Access Compliance Report

Public Rights-of-Way

Intersection ID: 32301	Main Street: BAILEYWICK_RD	Cross Street: HAZELVIEW_DR	Location: NE
ADA ID: 8B5282718BD8	Ramp Type: PerpDiag	Initial Pass/Fail: Fail	Overall Compliance: No
			Severity Score: 33.75

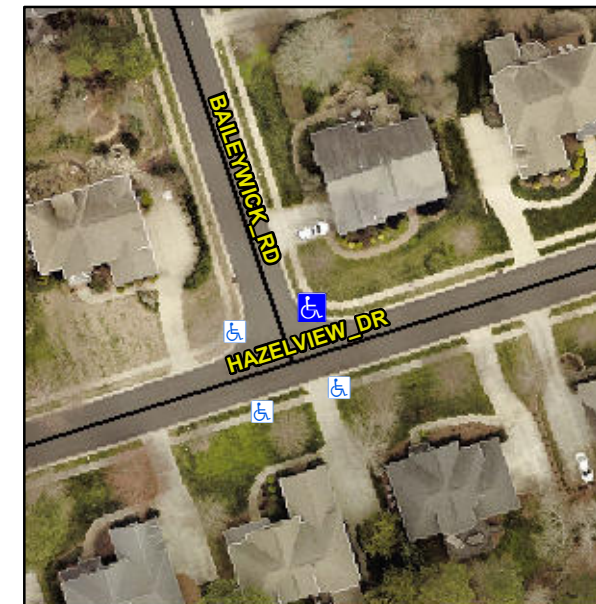
Not Found, R304.5.1, R304.5.3

Compliance	Description	Data	Compliance	Description	Data
N/A	Ramp Length (in)	96.0	Yes	Ramp Slope (%)	7.7
No	Ramp Width (in)	47.5	No	Ramp XSlope (%)	11.5
N/A	Flare Type LT	N/A	N/A	Flare Type RT	N/A
N/A	Flare Slope LT (%)	N/A	N/A	Flare Slope RT (%)	N/A
N/A	Flare Traversable LT?	N/A	N/A	Flare Traversable RT?	N/A
N/A	Landing Length (in)	N/A	N/A	DWS Provided?	N/A
N/A	Landing Width (in)	N/A	N/A	DWS Contrast?	N/A
N/A	Landing Slope (%)	N/A	N/A	DWS Length (in)	N/A
N/A	Landing X Slope (%)	N/A	N/A	DWS Full Width?	N/A
N/A	Landing Curb? (Y/N)	N/A	N/A	DWS Offset (in)	N/A
N/A	Shared Landing?	N/A			
N/A	Gutter Ponding?	N/A	N/A	Gutter Slope (%)	N/A
N/A	Gutter Lip Ht (in)	N/A	N/A	Gutter X Slope (%)	N/A
N/A	Painted X Walk1?	No	N/A	Painted X Walk2?	No
	X Walk 1 Direction	To W		X Walk 2 Direction	To S
N/A	X Walk 1 Width (in)	N/A	N/A	X Walk 2 Width (in)	N/A
	X Walk 1 Slope (%)	7.1		X Walk 2 Slope (%)	3.4
	X Walk 1 X Slope (%)	1.2		X Walk 2 X Slope (%)	4.6

Remove & Replace Curb Ramp With Two New Directional Ramps or Equivalent.
